## PIC16C745/765 Rev. A1 Silicon/Data Sheet Errata

The PIC16C745/765 (Rev. A1) parts you have received conform functionally to the PIC16C745/765 Data Sheet (DS41124C), except for the anomalies described below.

**FIGURE 1: USB TRANSCEIVER TIMING**

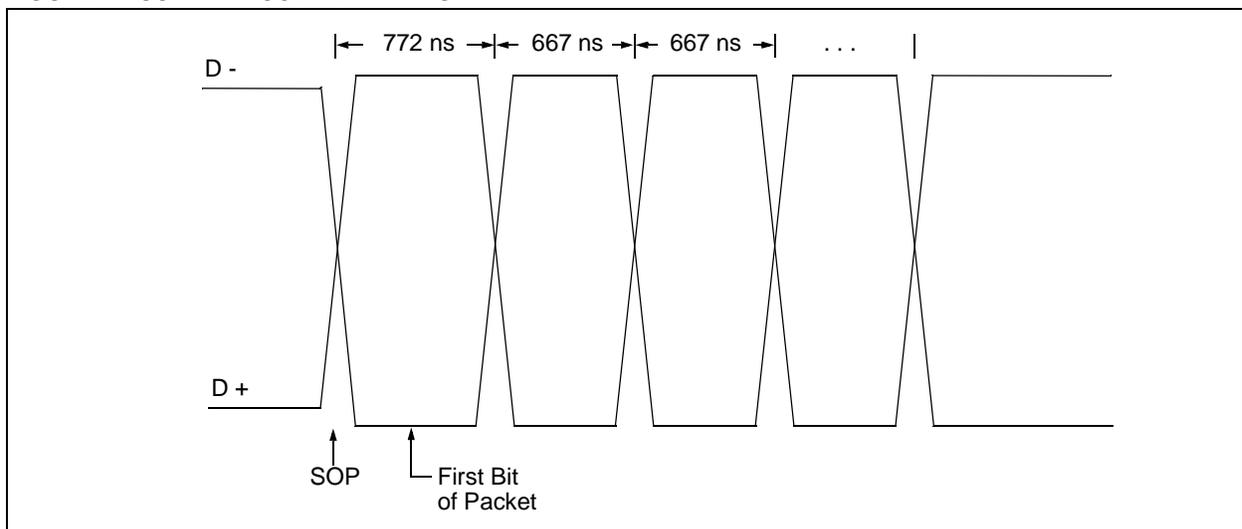
The first bit in the sync pattern during Microcontroller-to-host transactions is elongated by approximately 100 ns (see Figure 1). According to Section 7.1.11 of the USB Specification, Version 1.1, the bit period for a low speed device can vary 1.5% from 667 ns. This

means the average bit length can vary from 657 ns to 676 ns. Section 7.1.13.1 states, "For low speed transmissions, the jitter time for any consecutive differential data transitions must be within  $\pm 25$  ns and within  $\pm 10$  ns for any set of paired differential data transitions."

The initial bit from the PIC16C745/765, at approximately 772 ns in length, violates the consecutive transition jitter specification by 71 ns to 90 ns, depending on the actual data rate. It violates the paired data transition jitter specification by 82 ns to 120 ns, depending on the actual data rate. Devices based on the PIC16C745/765 are likely to fail the USB Implementer's Forum Compliance Test due to the jitter violation. However, the elongated bit does not affect the reliability of USB transactions between current USB host controllers and the PIC16C745/765. All packets are communicated successfully between microcontroller and host.

No work around available.

**FIGURE 2: UIR / USTAT REGISTER**

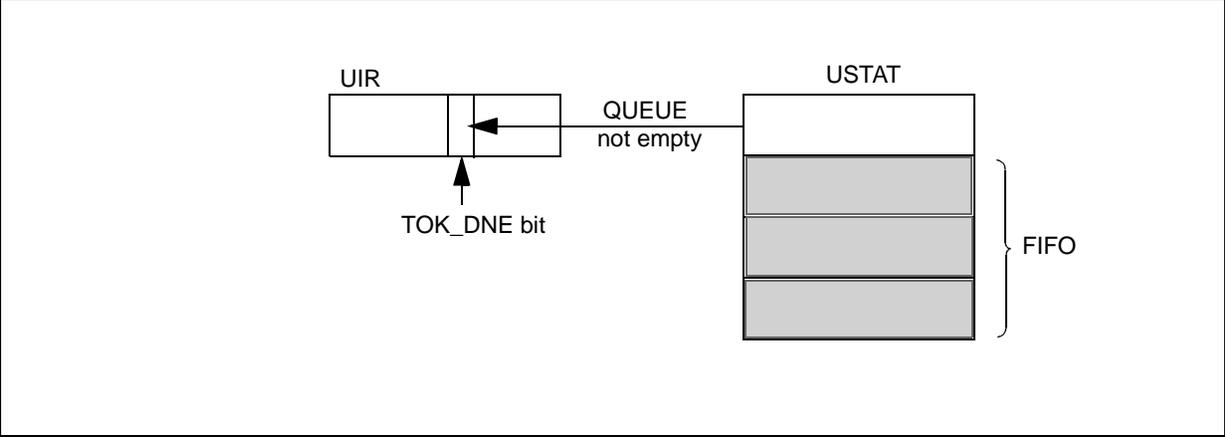
The TOK\_DNE bit (UIR Bit 3) is not set correctly for pending USB transactions in the USTAT register (see Figure 2). If additional transactions arrive prior to clearing the TOK\_DNE bit, they will be lost.

The interrupt driver Microchip firmware does not lose any transactions with current operating systems.

**FIGURE 7-1: TIMER1 BLOCK DIAGRAM**

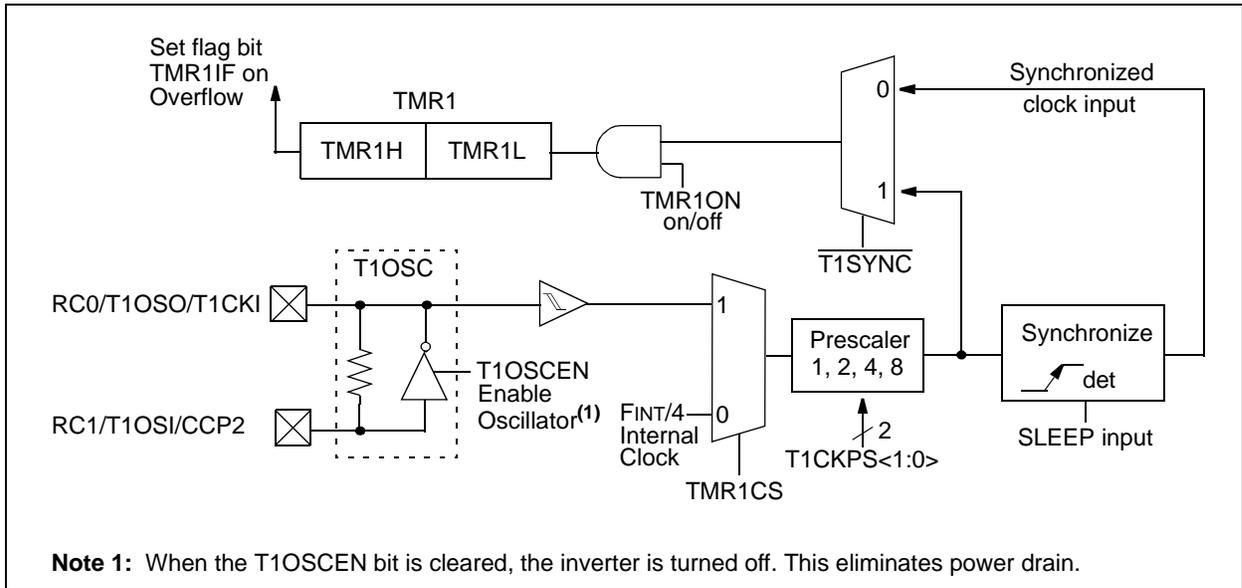
In Section 7.0, Timer1 module, there is an error in Figure 7-1. The label FINT should read FINT/4.
